Re: Revision To Administrative Order No. WFX-699  
Grayburg-Jackson Waterflood Project  
Eddy County, NM

**DEVON ENERGY CORPORATION  
APPLICATION FOR AUTHORITY TO INJECT  
GRAYBURG-JACKSON WATERFLOOD**

**DEVON ENERGY CORPORATION  
WELLBORE SCHEMATIC**

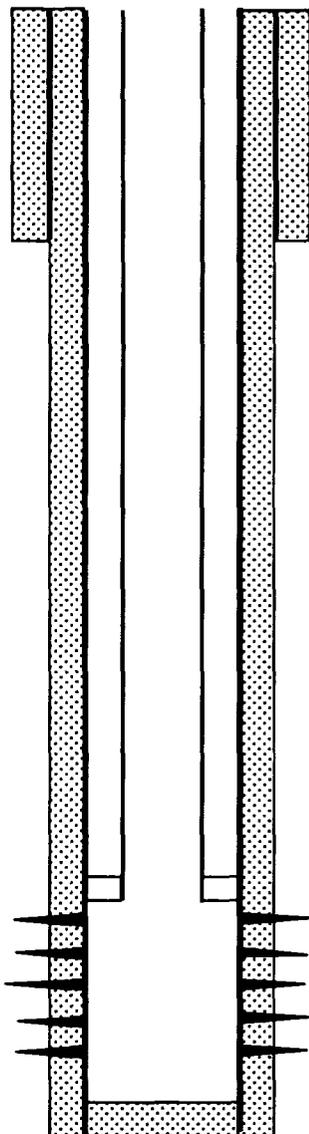
This well is a proposed redrill of the Friess Federal #1. It is necessary due to the poor mechanical integrity of the production casing which rendered the original well unsuitable for injection. The Friess Federal #1 has since been plugged and abandoned per OCD regulation.

- A.
- (1) Friess Federal #5  
2220'FSL & 1434'FEL  
Section 19-T17S-R31E  
Eddy County, NM
  - (2) Surface Casing:  
8 5/8" 24# J-55 ST&C @ 370'. TOC @ Surface  
Hole Size = 12 1/4"

- Production Casing:  
5 1/2" 15.5# J-55 ST&C @ 4200'. TOC @ Surface  
Hole Size = 7 7/8"
  - (3) Tubing will be 2 3/8" 4.7# J-55 EUE 8rd (IPC) set at 2600'.

- (4) 5 1/2" Baker AD-1 tension packer set at 2600'.
- B.
- (1) The injection formation will be the Grayburg/San Andres in the Grayburg-Jackson Field.
  - (2) Water injection will be through perforations 2650'- 3439'(OA). **The injection interval is 2650'- 3439'.**

WELLS WITHIN A ONE HALF MILE RADIUS OF  
FRIESS FEDERAL-5

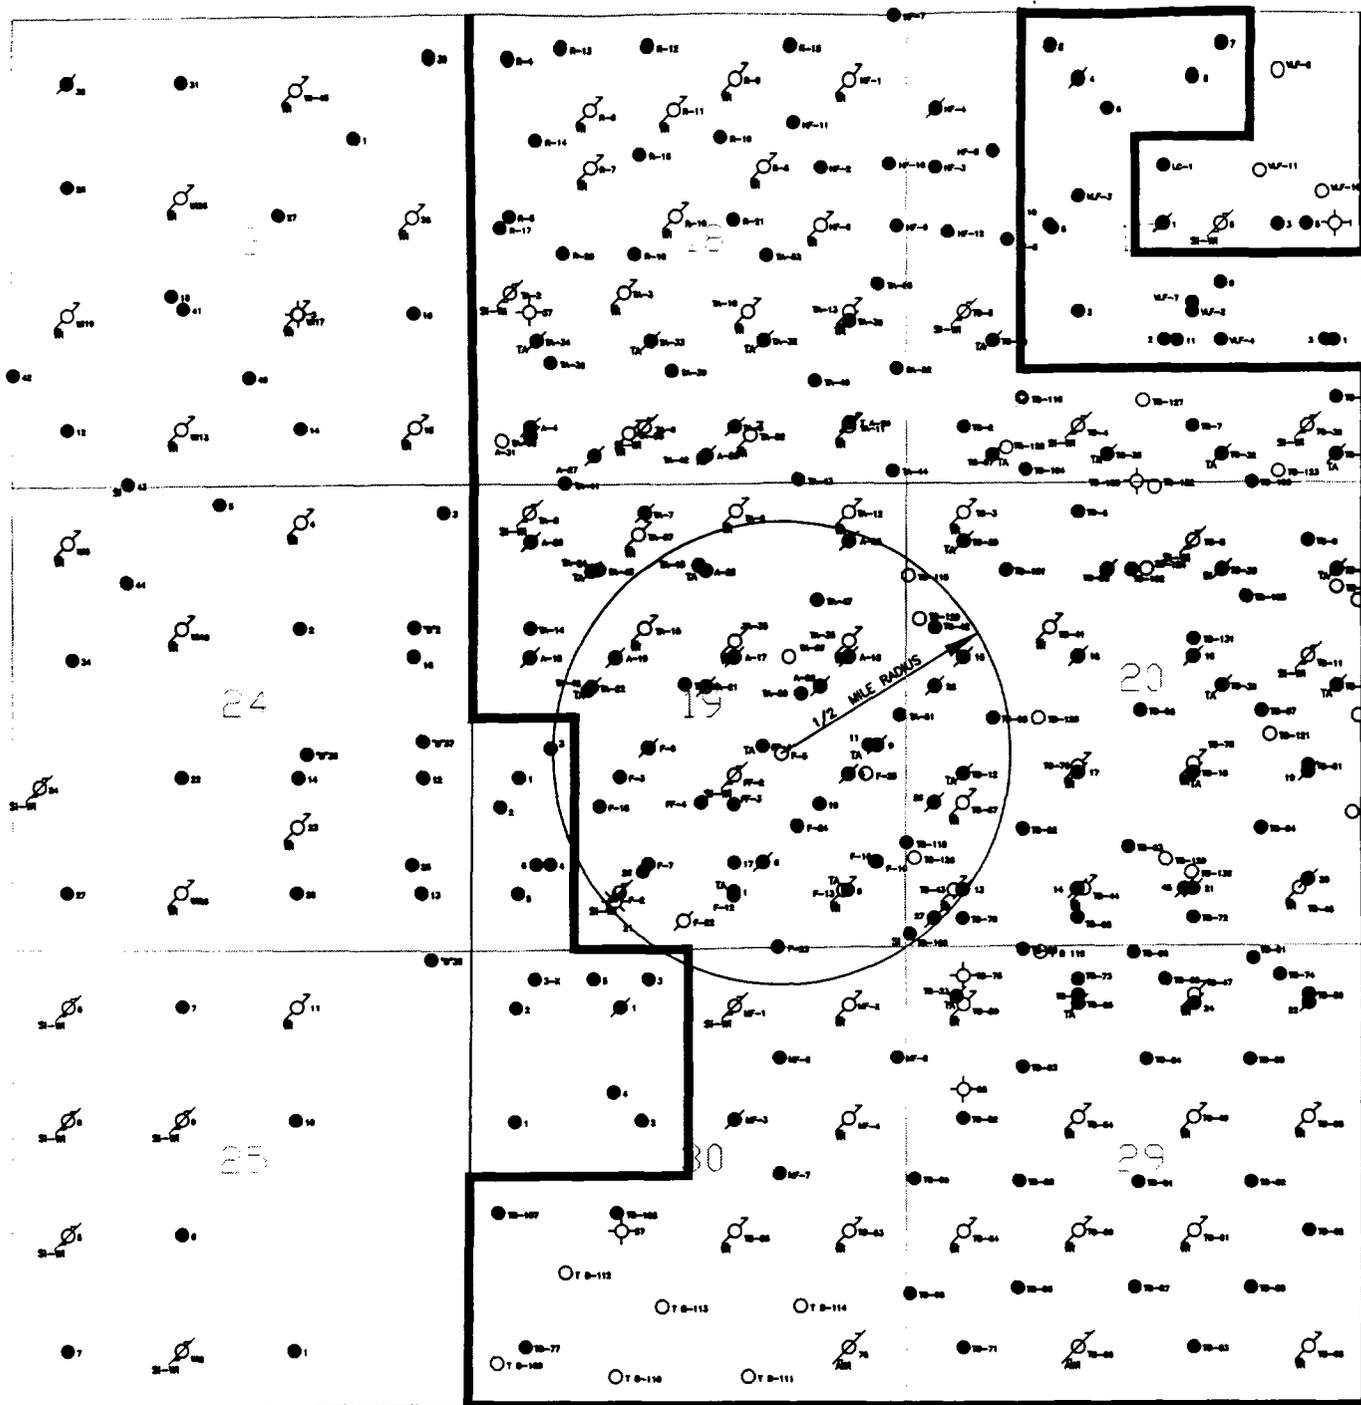
Due to the location of the replacement well no additional offset wells fall within the "Area of Review"; therefore, no additional offset well information was provided.
